Our Ref	22049-TN-1-R2
Date	24 February 2025
Author	Andrew Jameson
Client	Formula Land (Alderbury) Limited
Issued To	Simply Planning

Southampton Road, Alderbury

Noise Addendum in Response to ECP Comments

App Ref: PL/2024/09976

Daytime L_{Aeq} noise levels across existing site, 4m height

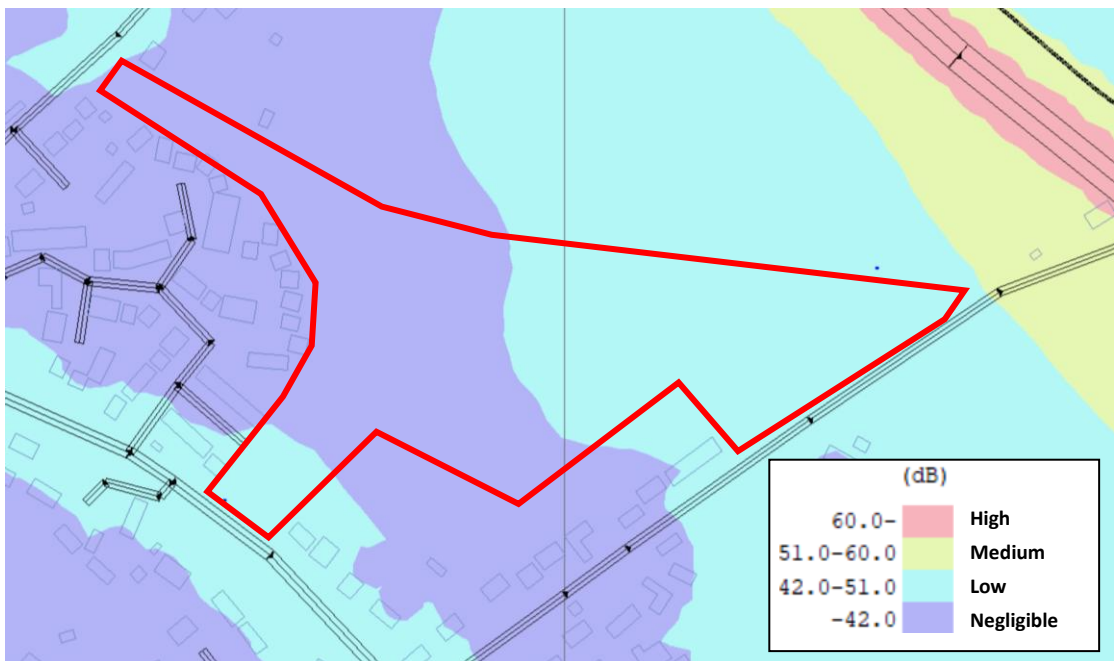
- 3.1 The ProPG Stage 1 initial site noise risk assessment is often omitted from Reports for brevity in cases where there are no significant risks to evaluate, i.e. when noise levels across the site are clearly, from the survey readings, in the ‘low’ or ‘negligible’.
- 3.2 However, for completeness, please see below the daytime and night-time L_{Aeq} noise levels plots across the existing site.

- 3.3 The 10th highest night-time L_{Amax} noise event levels do not exceed 60 dB for the majority of the site, which ProPG considers to be the threshold below which the site can be regarded as negligible risk. The levels only exceed 60 dB for the limited area to the south of the site near Southampton Road and to the north-east corner of the site.

- 3.4 The above plots provides a clear indication that the site falls within the 'low' to 'negligible' noise risk categories, with the vast majority of the site falling within the 'negligible' category.

Noise model highlighting facades achieving 'ideal' internal noise levels, in 'black' (Level 1, worst-case)

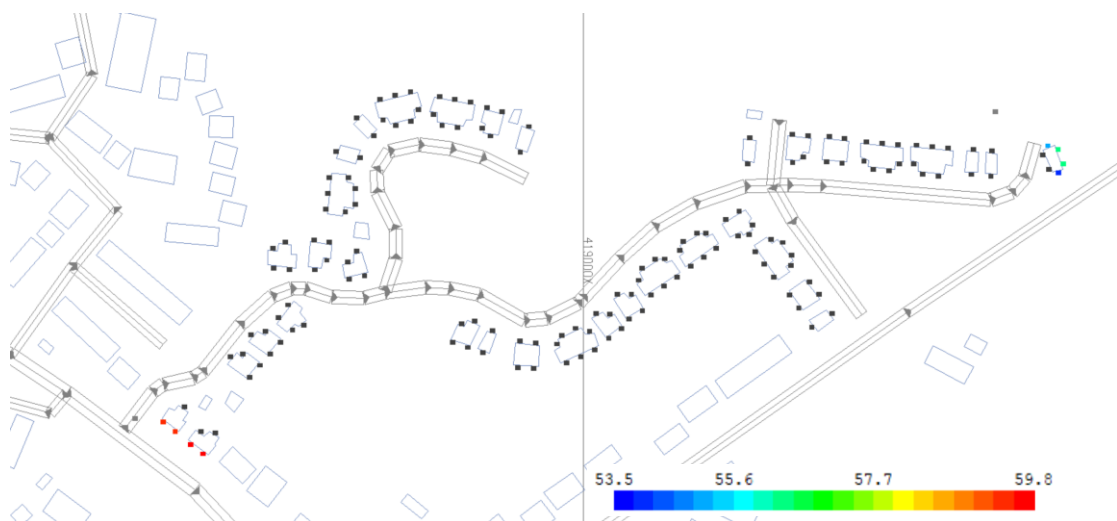
- 5.2 Site-wide, the Report advises that opened windows for background ventilation should only be rely on for 14nr of the 47nr dwellings to achieve 'ideal' (as defined in BS 8233) internal noise levels. This was advised on a rather caution approach. However, if we consider the typical external to internal sound level difference afforded by a façade with a partial opened window of 10-15 dB (as advised in the WC guidance note, with 13 dB being the commonly used figure in calculations), then any façade subject to incident noise levels not exceeding 48 dB $L_{Aeq,16hr}$ daytime or 43 dB $L_{Aeq,8hr}$ night-time in theory achieve internal noise levels of 35 dB $L_{Aeq,16hr}$ daytime and 30 dB $L_{Aeq,8hr}$ night-time with windows open. We have reevaluated the noise model to determine which dwellings would achieve this and the results are illustrated below.

- 5.3 In the above Figure, any façade marked 'black' fall within the noise threshold advised in 5.2 whereby acceptable internal noise levels are achieved with windows partially open. If we discount the side elevations of each dwelling (no windows), this shows that of the 94nr facades with windows to habitable rooms across the scheme (47nr dwellings x 2, front and rear elevations), only 18nr façades would fail to achieve internal noise levels with windows open. This represents only 19% of the development.

Noise model highlighting facades achieving 'reasonable' internal noise levels, in 'black' (Level 1, worst-case)

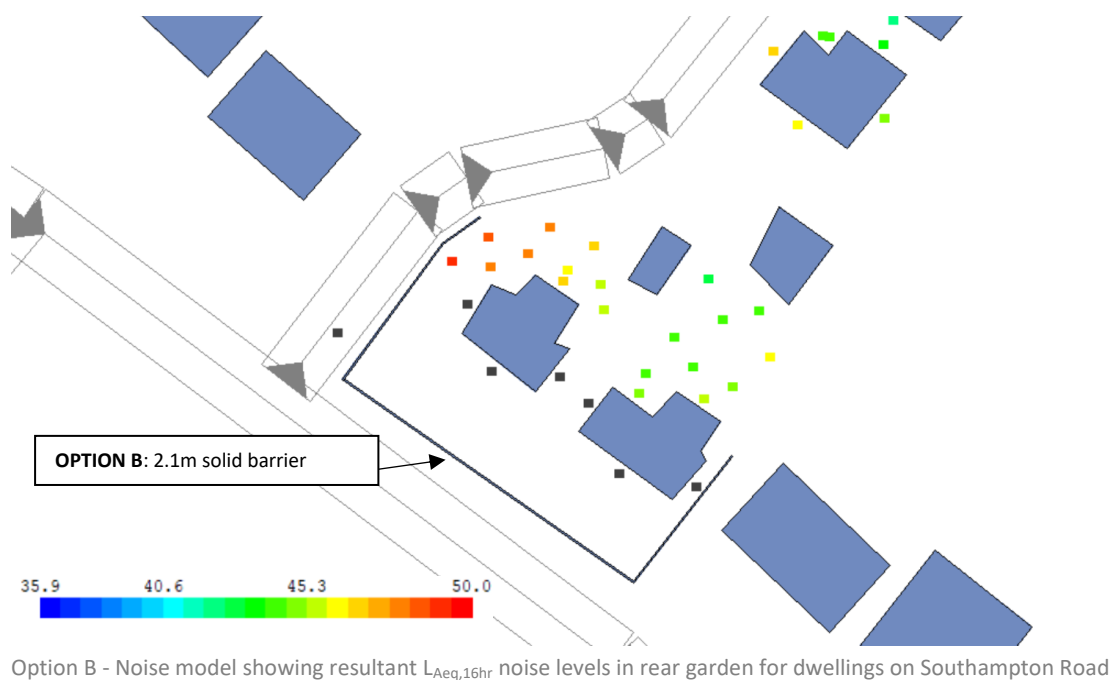
- 5.4 If we consider BS 8233's 'reasonable' internal noise levels, which are +5 dB above the ideal noise level targets, this number reduces to just 4nr façades (namely, the two front elevations of dwellings on Southampton Road and the north facing elevation of the dwelling in the far north-east corner of the site). This represents only 4% of the development. Note, these facades will still have openable windows for purge, as well as the option to close windows whilst still maintaining fresh air background ventilation by means of trickle ventilators.

Baseline noise model of daytime $L_{Aeq,16hr}$ noise levels across site (no solid barriers)

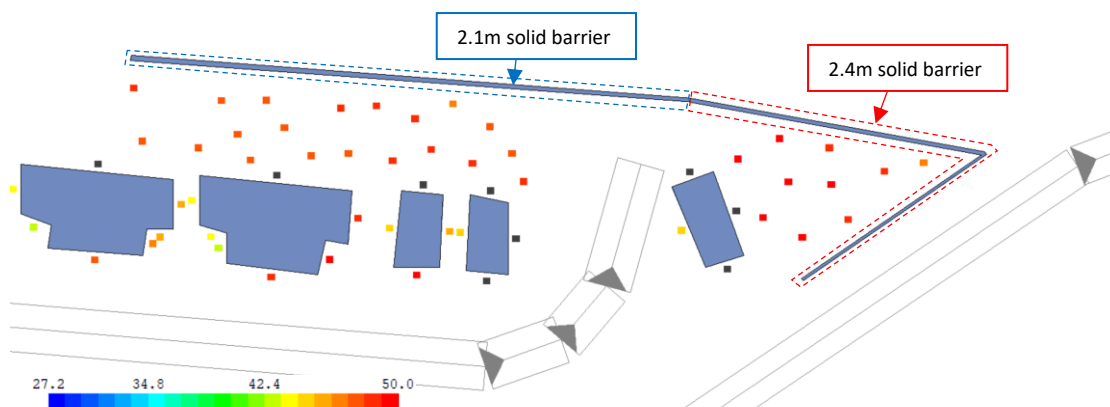
- 6.1 The Report identified the garden of only a single dwelling to the north-east corner of the site would require solid barriers (e.g. fencing) to achieve the BS 8233 limit of 55 dB $L_{Aeq,16hr}$. All other gardens would achieve this standard without additional treatment.
- 6.2 WC has, however, advised that efforts should be made to achieve 50 dB $L_{Aeq,16hr}$ in all gardens. We have therefore reassessed the need for localised treatment, solid barriers, as follows.
- 6.3 The following Figure presents the baseline (no solid barriers) noise model at a height of 1.7 metres above ground level (typical ear height when standing) to show which dwellings achieve or exceed this 50 dB $L_{Aeq,16hr}$ target.

- 6.4 The results demonstrate that potentially 8nr of the 47nr dwellings could experience noise levels greater than 50 dB $L_{Aeq,16hr}$ in rear gardens (the two dwellings on Southampton Road to the south and the 6nr dwellings in the farthest north-east corner of the site).
- 6.5 For the two dwellings on Southampton Road to the south, we have modelled two location options for a 2.1-metre tall solid acoustic barrier to the extends as indicated below. The results of the noise model indicate that at typical ear height (when standing) noise levels in both rear gardens would satisfy WC's desired target of 50 dB $L_{Aeq,16hr}$.

Noise model showing resultant $L_{Aeq,16hr}$ noise levels in rear garden for dwellings to north-east of site

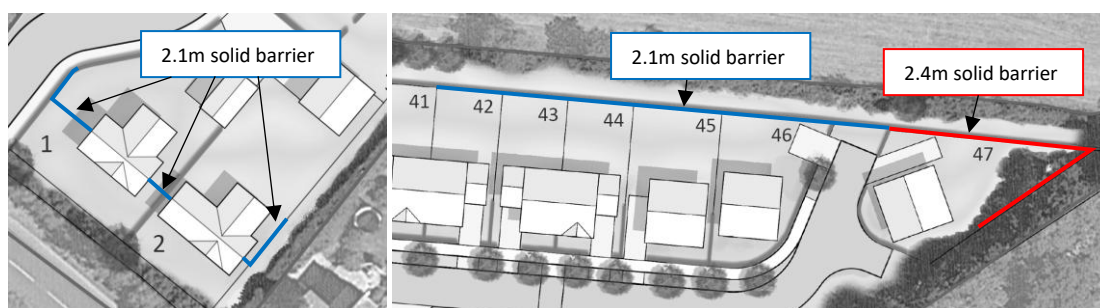
6.6 For the six dwellings to the north-east corner of the site, we have modelled a 2.1-metre tall and a 2.4-metre solid barrier to the extends as indicated below. The results of the noise model indicate that at typical ear height (when standing) noise levels in all rear gardens would satisfy WC’s desired target of 50 dB $L_{Aeq,16hr}$.

- 6.7 The barrier could be formed from brickwork or a closed panel (imperforate), providing a minimum mass per unit area of 12 kg/m^2 (e.g. timber). A more precise mark up of the barrier locations/sizing is provided below.
